Addendum No. 2

Reference: Regional Training Institute – TASS Phase 2
Utah National Guard – Camp Williams, Utah
DFCM Project No. 11020480

ISSUE DATE:	1 April 2013
RESPONSE TO:	Contractor Requests for Information & DFCM Comments
PROJECT:	**RTI TASS Complex, Phase II** **Administration & Billets Buildings** 17800 South Academy Street Utah National Guard Camp Williams **DFCM'S PROJECT #:** 11020480 **NGB'S PROJECT #:** 490444 **ARCHITECT'S PROJECT #:** 11024
OWNER:	**Utah National Guard** 12953 South Minuteman Drive Draper, Utah 84020-1726
SUBJECT:	**VARIOUS CLARIFICATIONS**
ATTACHED:	**VOLUMES A.1 & A.2**

A1 DOOR TYPES
AE601 1/4" = 1'-0"

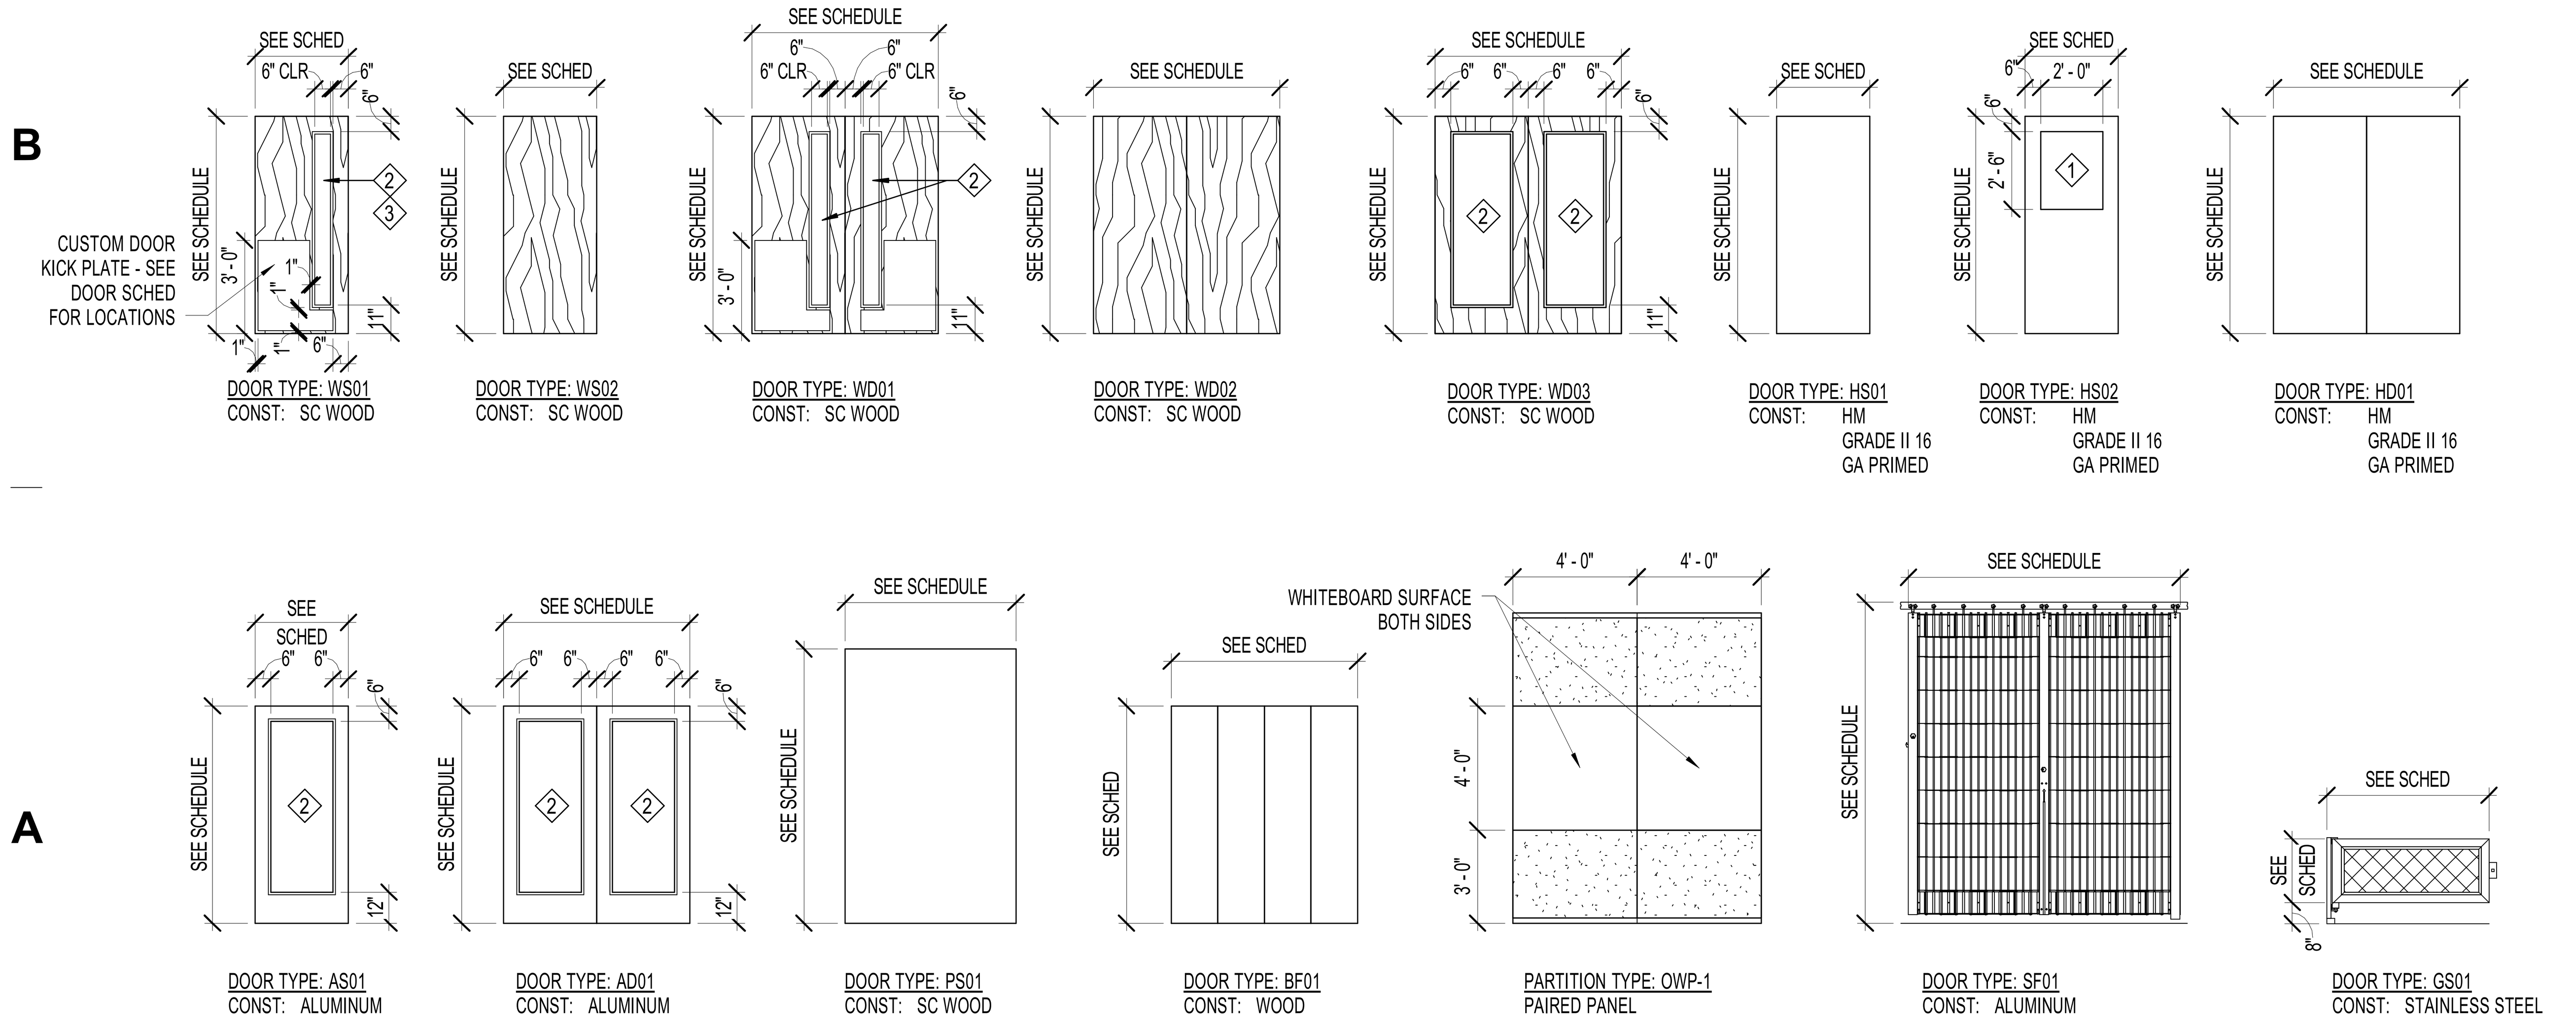
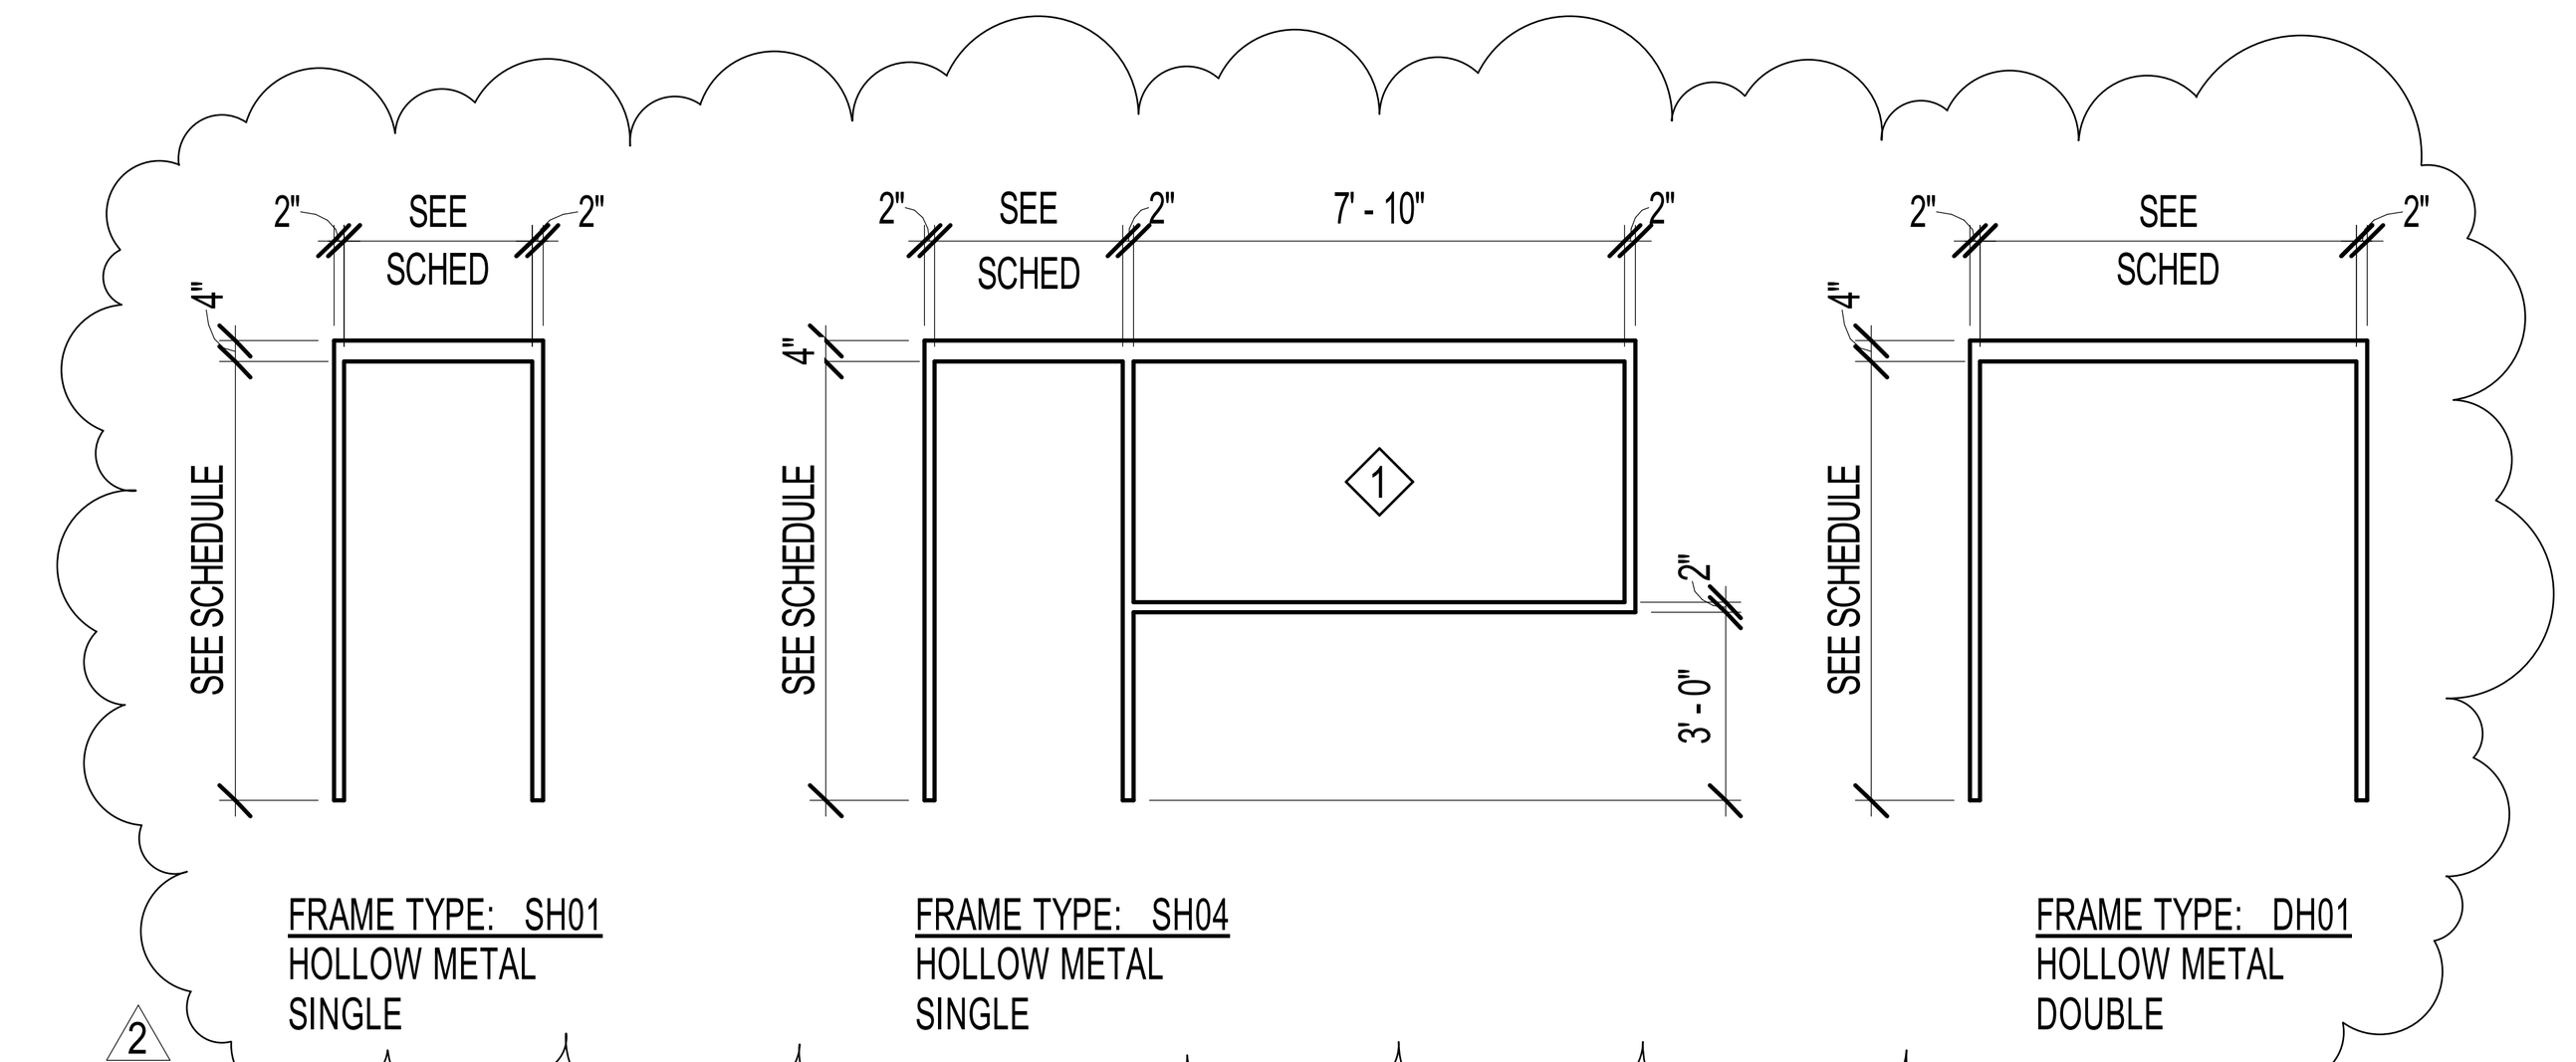
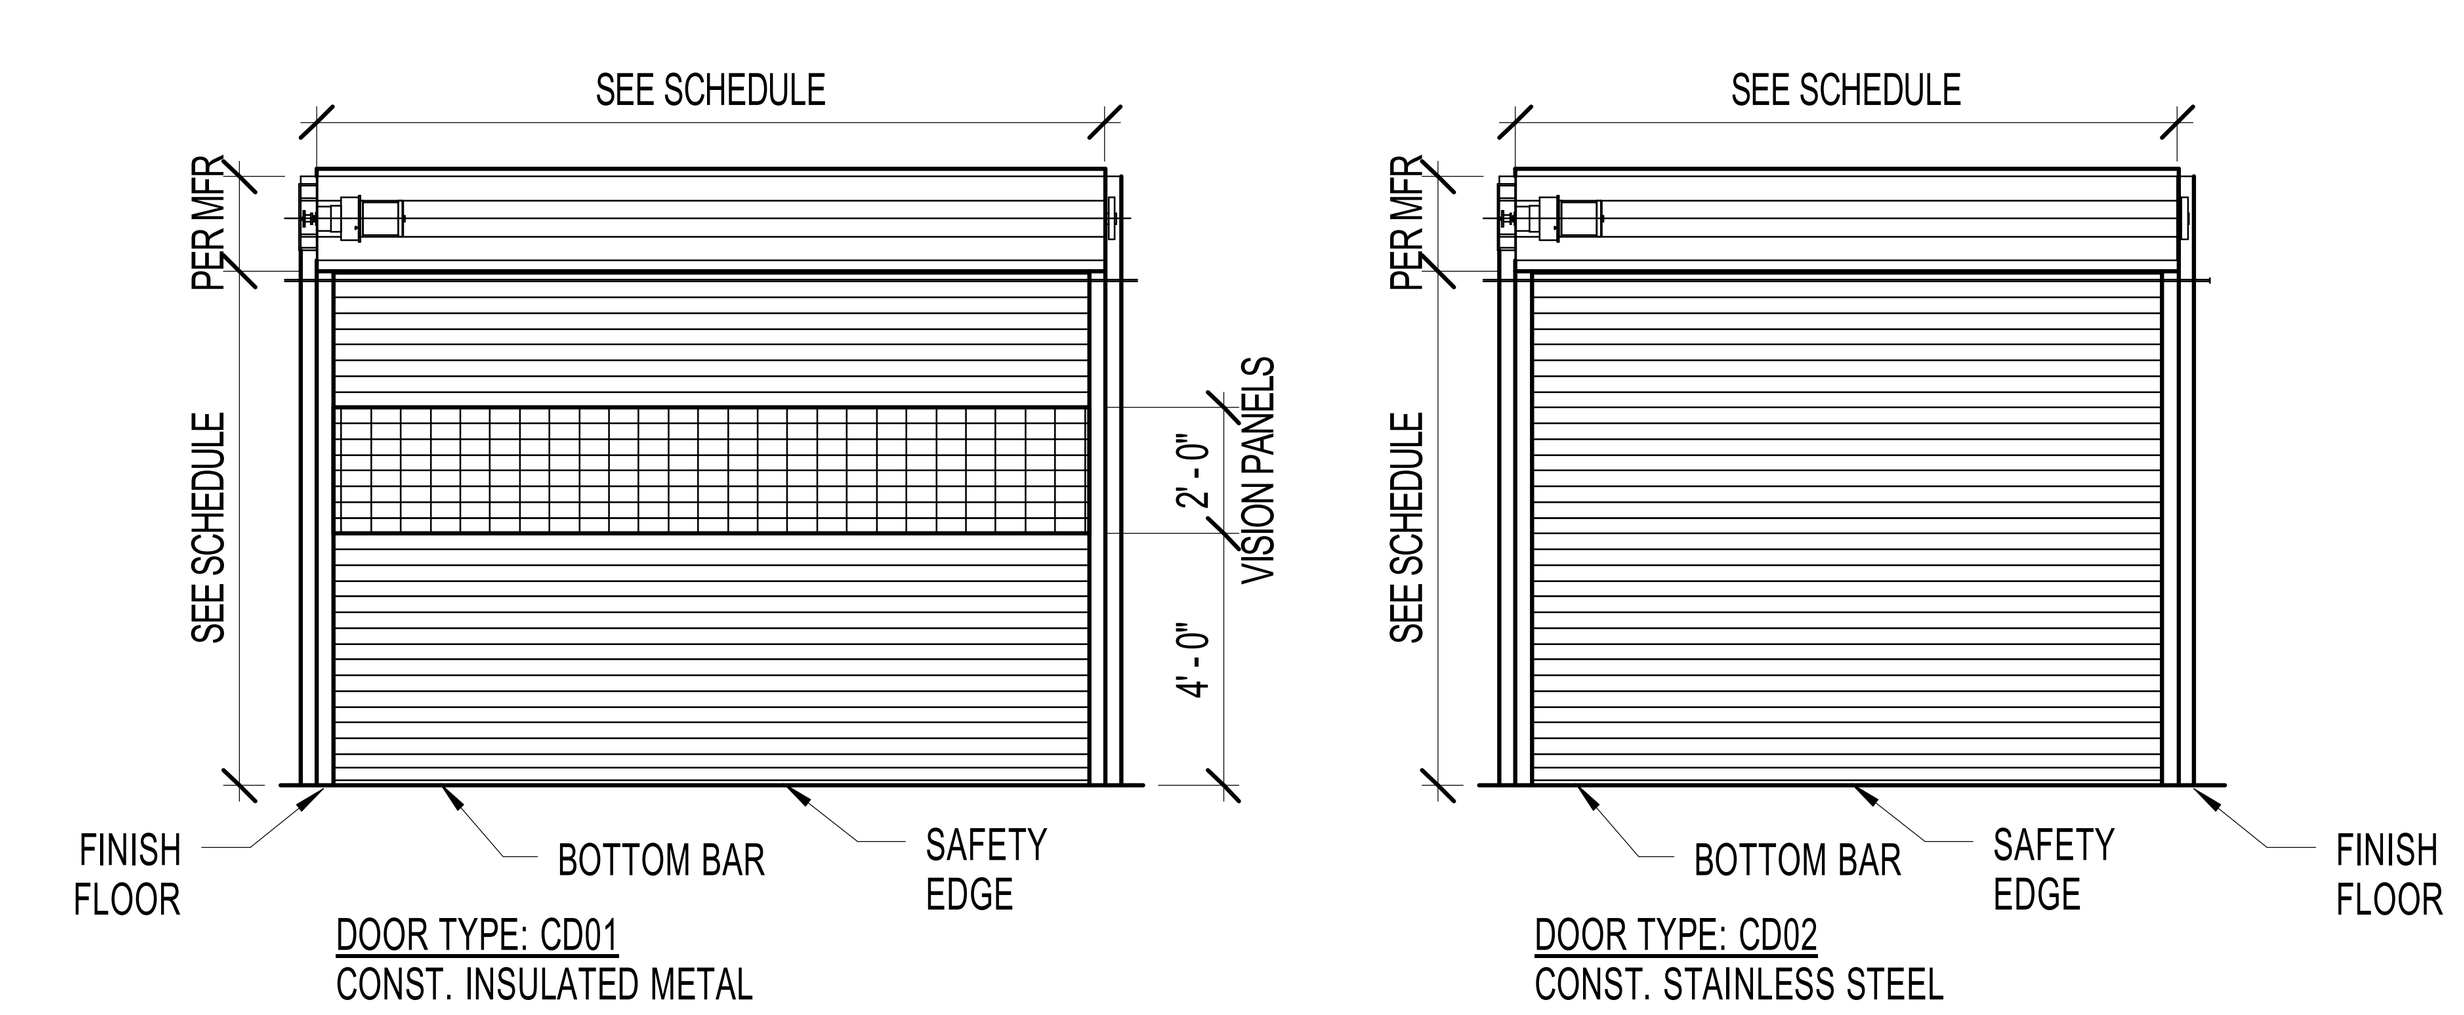
A4.12	AE514	**REISSUE** sheet as provided. Multiple revisions across all details. Note that details A1 and C1/AE514 have been added to the sheet.
A4.13	AE601	**REVISE** door schedule as shown on sheet provided. **REVISE** frame types B4/AE601 to have hollow metal types 'SH01', 'SH02', and 'DH01', as shown on sheet provided.
A4.14	AE630	**DELETE** and **REPLACE** details D1 and D5/AE6630, with D1 and D4/AE630, respectively, as shown on sheet provided. **REVISE** details B3, B5, B6, and C6/AE630 as shown on sheet provided. **ADD** details D6 and E6/AE630, as provided on sheet.

C4 GI101 BILLETS LEVEL 2 LIFE SAFETY PLAN (LEVEL 3 SIM)
1/16" = 1'-0"

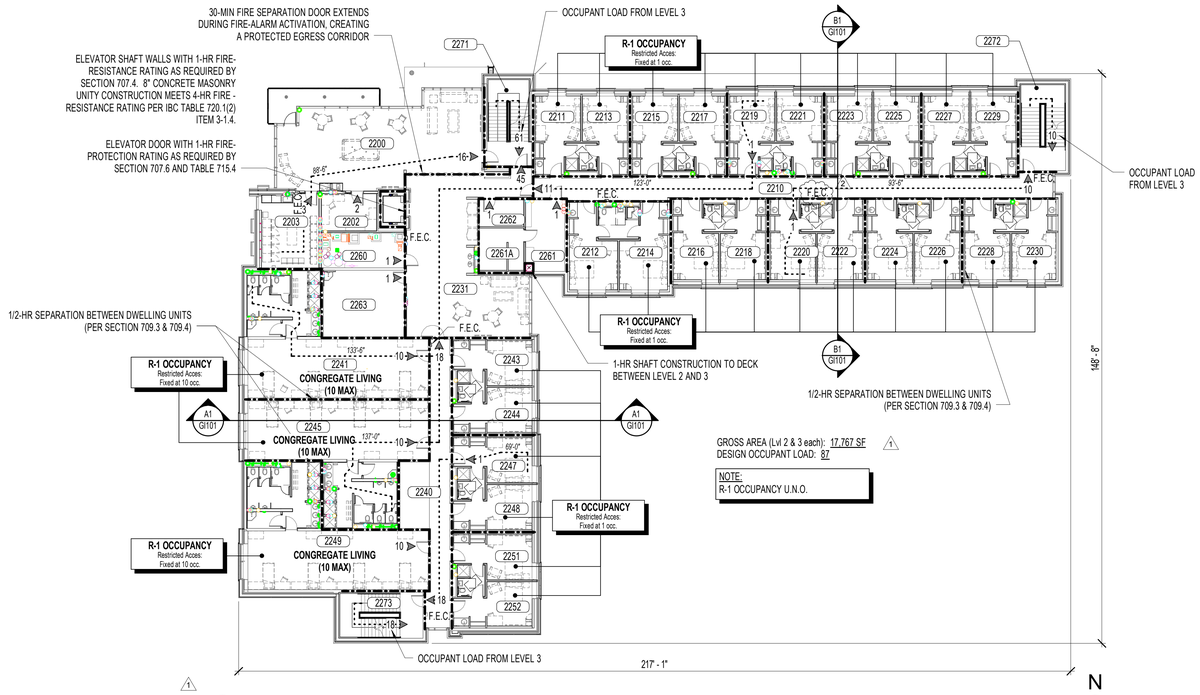
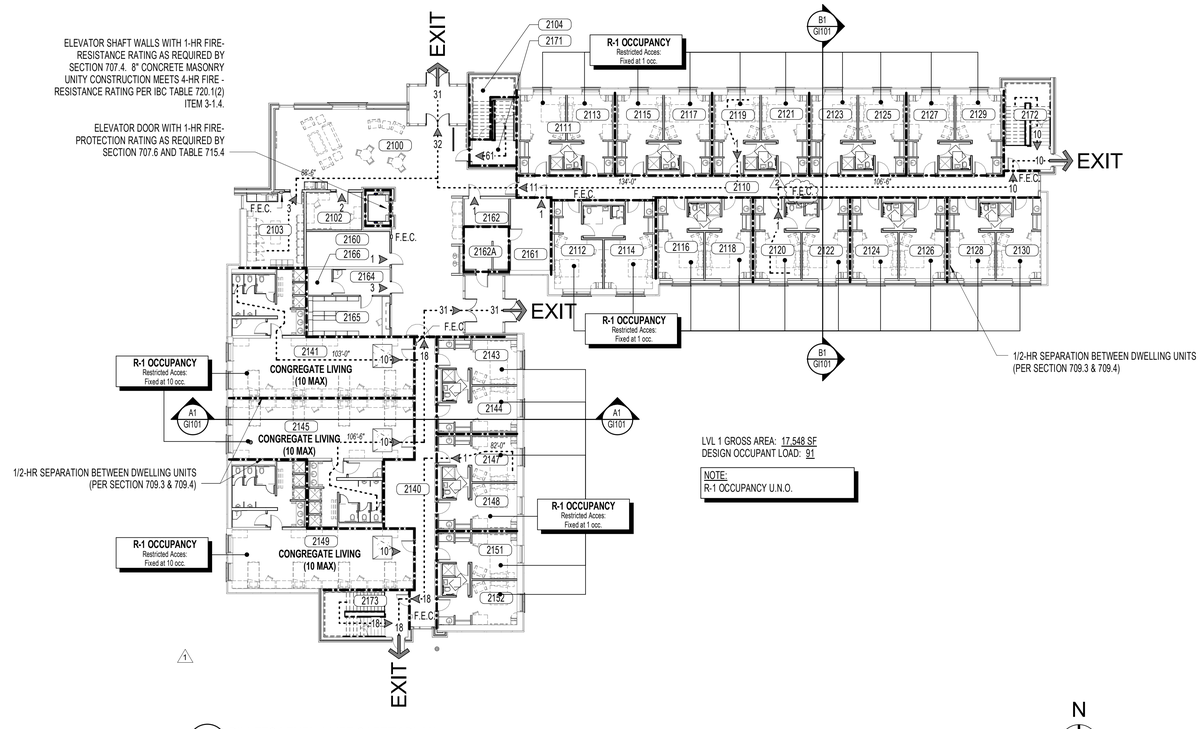
Item #	Sheet(s)	Amendment
B1.03		
B1.04	GI101	**REVISE** plans A4 and C4/GI101 to have a FEC cabinet between rooms 2120 and 2122; 2220 and 2222; and 2320 and 2322. **ADD** the following rated construction information to "Floor – Ceiling Floors" on CODE ANALYSIS table: Rating to be '1/3 Hours' and assembly listing to be 'D974'.
B1.05	GI110	**ADD** the following to the DEFERRED SUBMITTALS LIST: • FIRE ALARMS…… 6 MONTHS • EVALUATION REPORTS (ICC OR EQUIVALENT FOR THE FOLLOWING: f. FIRE DAMPERS …… 6 MONTHS
B1.06	GI512, GI513, GI1514	**ADD** UL Design No. D974 to sheet GI513, which rearranges details to across sheets GI512 and GI513. **ADD** sheet GI514, as provided.
